Laura Lake, Ph.D., Board Secretary, Fix the City

November 10, 2020

RE: REVOCATTION OF **BUILDING PERMIT APPLICATION #16010-20000-02308** AND CERTIFICATE OF OCCUPANCY/TEMPORARY CERTIFICATE OF OCCUPANCY FOR **1751 MALCOLM AVENUE & 1772 GLENDON AVENUE**

Figure 1. Fault line at southern boundary of 1772 Glendon Avenue not investigated – requires 50-foot setback.

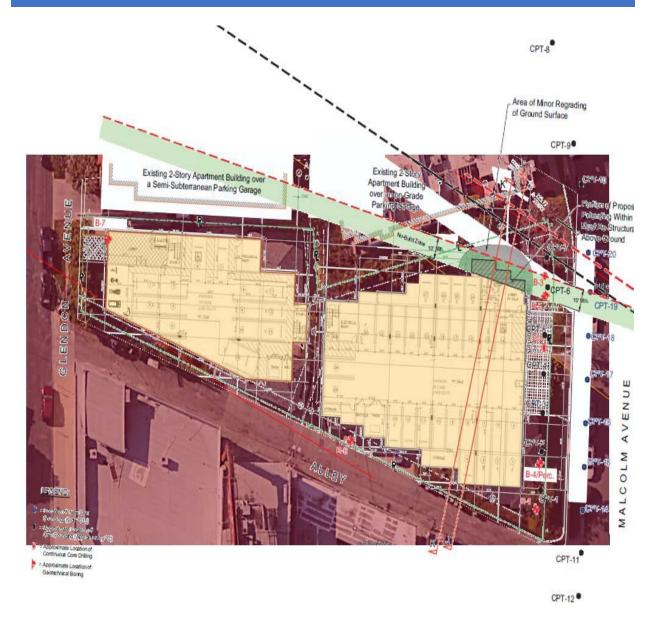
- The cantilevered structure at 1751 Malcolm over the no-build area violates LAMC 91.106.4.1 Exception 4.<sup>1</sup>
- There is a **second fault** line along the alley for both 1772 Glendon and 1751 Malcolm that was not investigated (see Figures 1 and 2). Under the Alquist Priolo Act Section 3603(a), the City lacks authority to waive a 50-foot no-build zone from the property line for 1772 Glendon and 1751 Malcolm along the southern boundary of the site in the absence of a fault investigation. *None was conducted for the southern fault.*

• There was no investigation of the southern fault along the alley. Therefore, there must be a 50-foot no-build area along the alley fault line for 1772 Glendon and 1751 Malcolm.

Based on CGS and USGS fault lines within the AP Fault Map for this site, the *City failed to require an investigation of the fault on the southern boundary* of 1772 Glendon Avenue and 1751 Malcolm Avenue *as shown above in Figures 1 and 2*. *This was a gross prejudicial abuse of authority*.

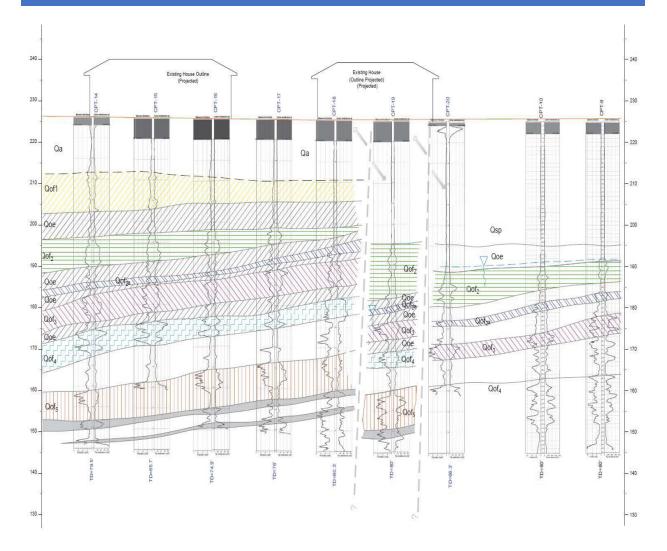
The December 29, 2015 denial summary from LADBS (Exhibit C) incorrectly claims the fault was in the **northeastern** portion of the site, when the fault rupture study on page 27 of FER 259 shows it running through the center of the site between *CPT 18 and CPT 19 as shown below in Figure 3.*

FER 259 is binding upon the City. It cannot under state law, impose weaker conditions. **The no-build area is required, and it is in the center of the site, not the northeastern edge, based on Figure 16 in FER 259**. Based on his sending the 2016 studies to CGS, and his two previous denials, Mr. Schneidereit was clearly aware of the role of CGS in regulating surface rupture fault investigations and of the recommendation for a no-build area.

1751 Malcolm Avenue is built over the active fault viewed from Malcolm Ave. (Source: Fix the City).

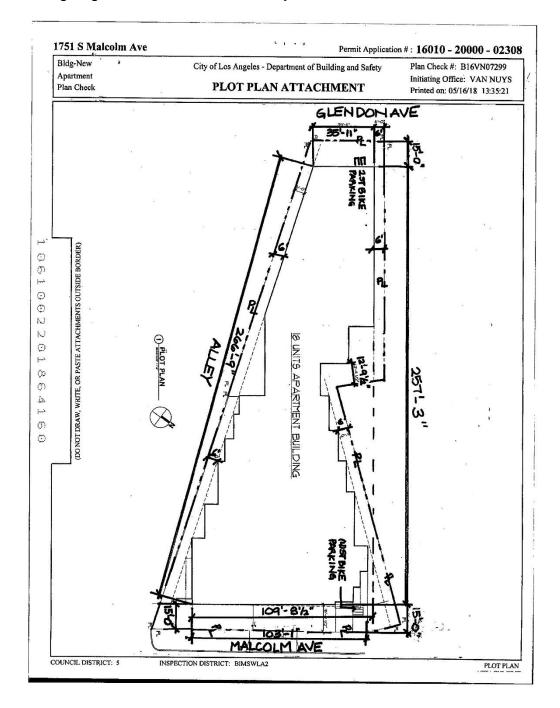
**CPT-18 and CPT-19 are NOT in the northeastern portion of the site.** They are on the right side of the garage entrance shown in the photo above. The plot plan attached to the building permit, shown on the next page, shows that the entire site was built over with a few zig-zags on the northern boundary and not around CPT 18 and CPT 19.
